XPROG-m Errata Sheet 001

This errata provides information applicable to the following products:

- 1-002-0017 programming adapter Rev.B or earlier

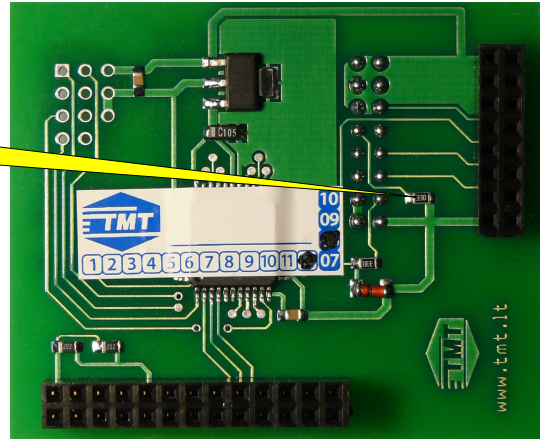
These changes allow you to work with secured ARM MCU via JTAG interface

STEP1

Remove this resistor

STEP3

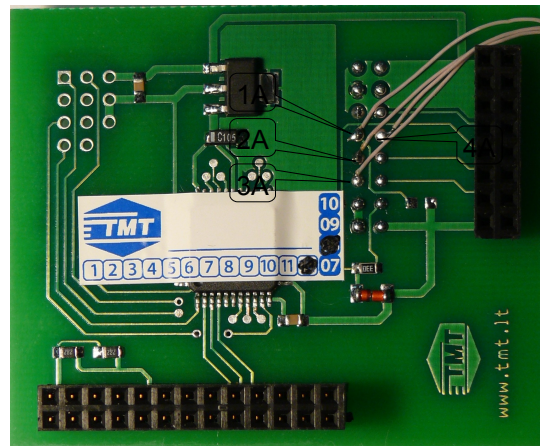
- Solder wire shown in the corresponding points at the bottom side

- Solder wire shown in the corresponding points at the top side
